SPARS NEW YORK REGIONAL MEETING

REVIEW : "PROBLEMS AND SOLUTIONS / AMPEX 1200"
SPEAKER: MICHAEL GUTHRIE, DIRECTOR OF ENGINEERING
RECORD PLANT STUDIOS, LTD. -NYC

Record Plant Studios MM-1200 modification procedures:

CHANGES AND ADDITIONS TO TAKEUP TENSION CONTROLLER KIT * Record Plant Studios
2/16/81

TRANSPORT CONTROL BOX SUPPORT SHELF
NEW HOLES LAYOUT

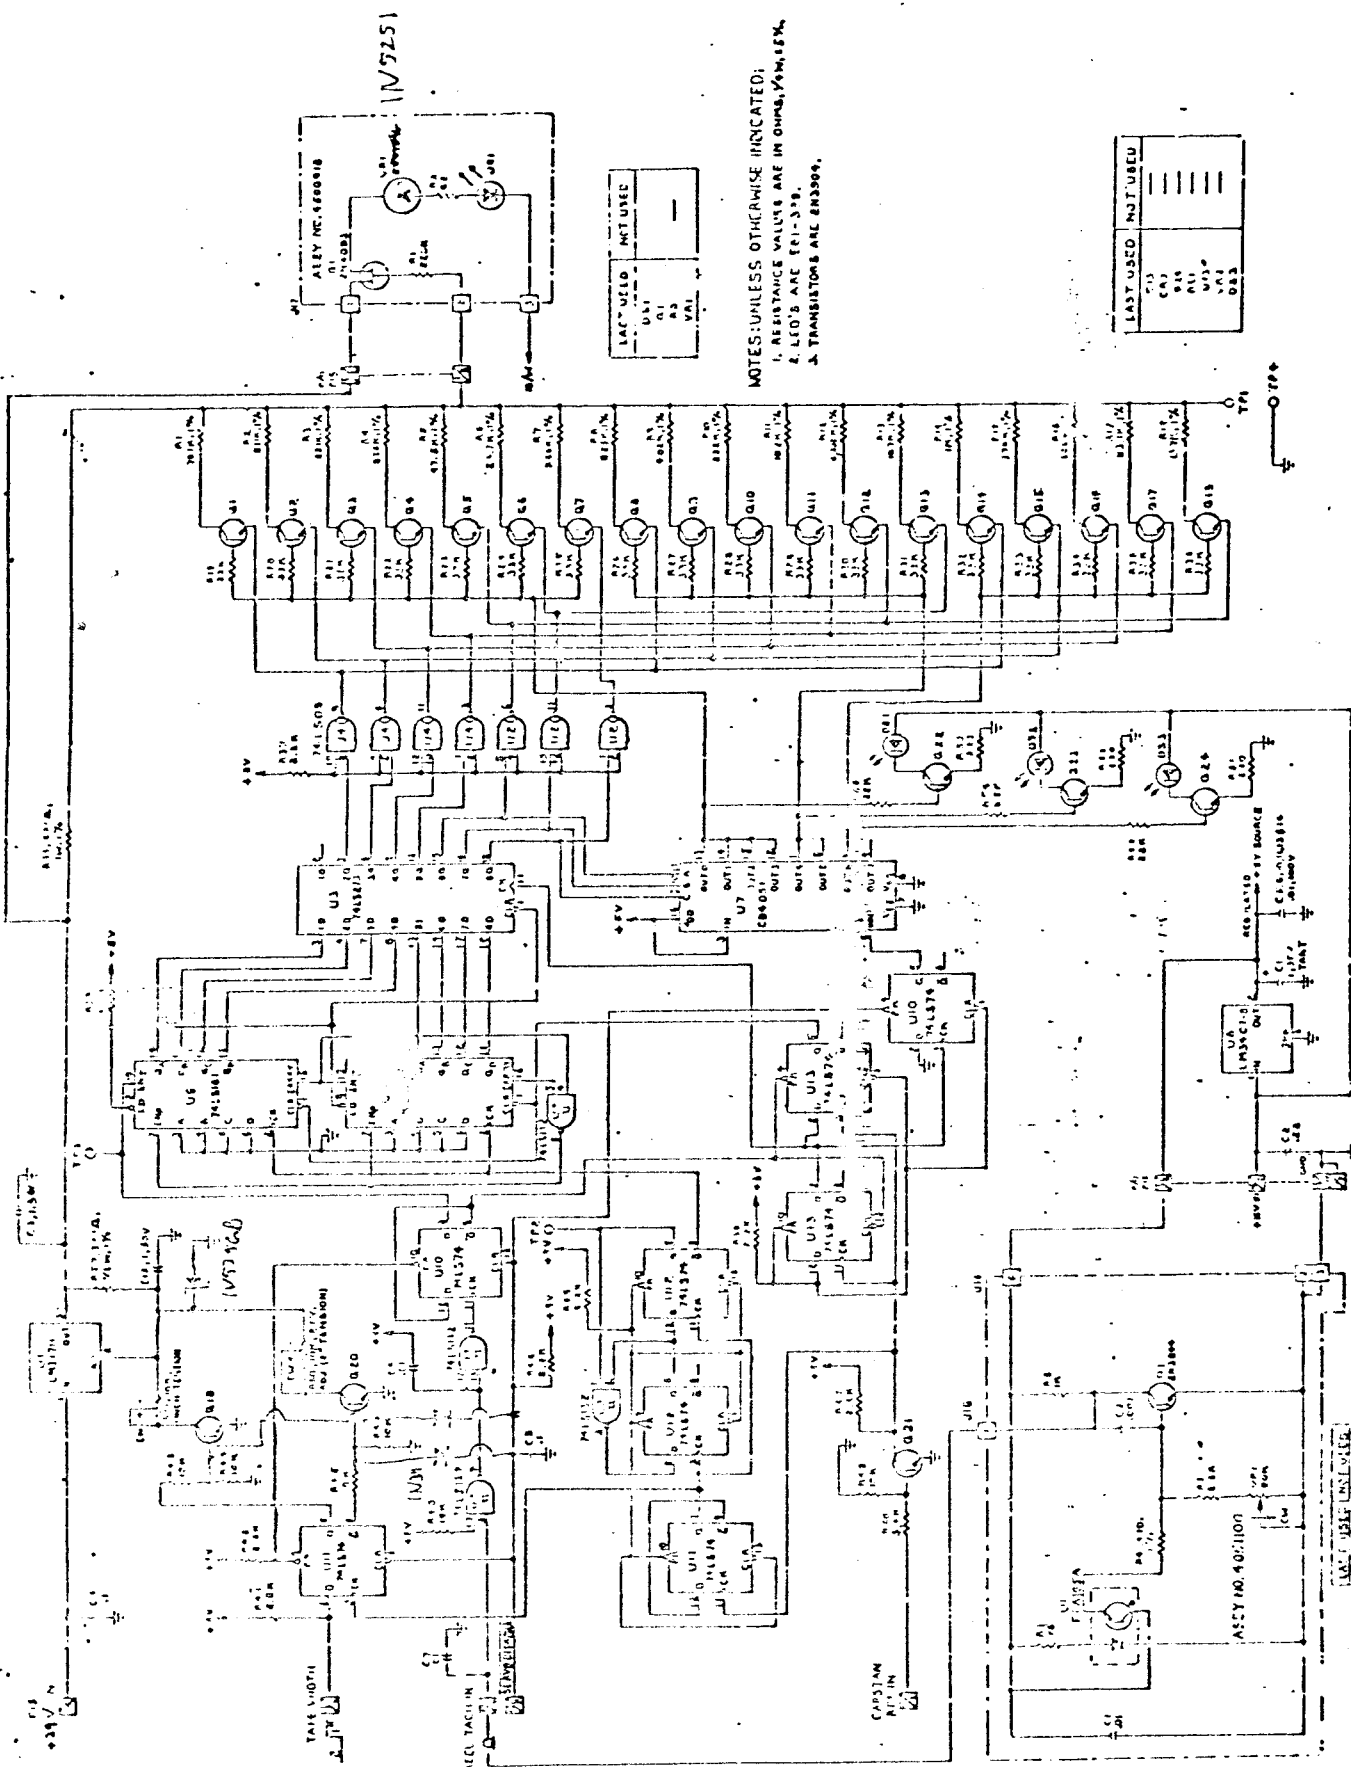
4.5 DRILL TWO HOLES 0.2 INCHES IN DIA. ON A LINE 0.62 INCHES FROM THE FRONT EDGE OF THE SHELF. THE HOLES ARE 5.2 INCHES APART AND THE FIRST HOLE IS 2.5 INCHES FROM THE LEFT EDGE OF THE SHELF.

4.6 MOUNT TENSION CONTROLLER MOUNTING BRACKET WITH TWO NO. 8-32 SCREWS AND FLAT WASHERS SO THAT IT EXTENDS DOWNWARD FROM THE SHELF WHEN THE SHELF IS IN ITS NORMAL POSITION. THE SLOTS FOR THE PWA EDGE CONNECTOR SHOULD BE TO THE LEFT. SET ASIDE THE RESULTING ASSEMBLY UNTIL A LATER STEP.
